Your No 44 dated January 9th
respecting Bellary Aramal.

BELLARY ARSENAL, Presumed Section of Ground

W. shifts explanation as to the omission to lay down the gravel protection provided for in the estimate for the Arsenal workshops at Bellary.

Bellary Arsenal Workshops

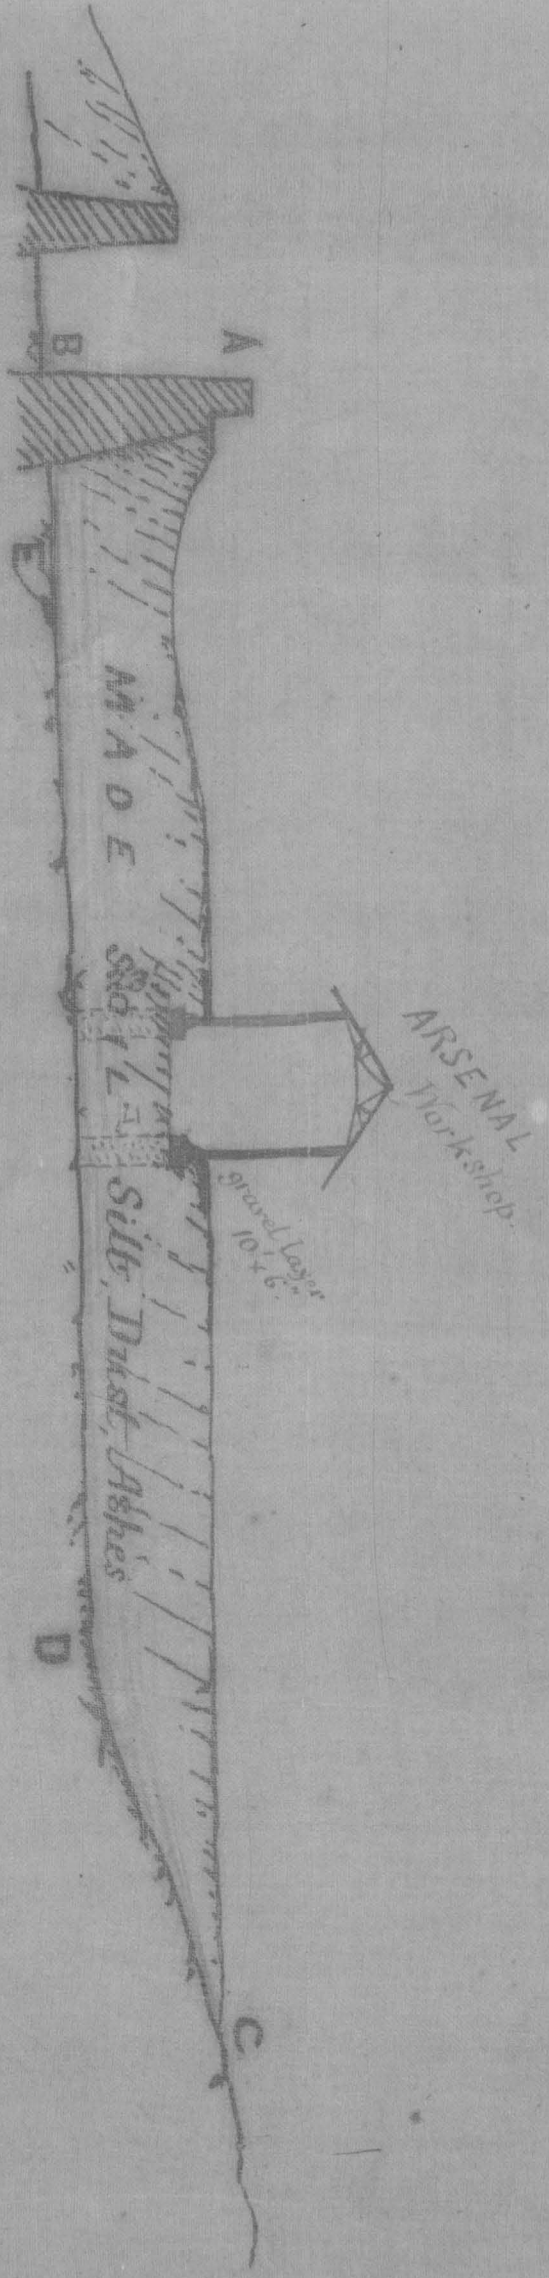
8. I give a presumed section of the ground, but which although only presumed, I do not think can be far from the truth, to illustrate this.

Not merely would there be a percolation through the weak soil but there would

also be a creep of water along C.D.E. the drainage from the high ground beyond, the water entering at the junction of the mass soil with maiden earth, probably rock or gravel and comparatively impervious.

The pressure of this water caused the partial failure of the rampart and the consequent cracking of the mass earth as remarked by Mr. Russell. And this assumption will be borne out if the ground in the pit excavation was found damper as the excavation was carried downwards. How could a gravel platform have prevented or even modified this?
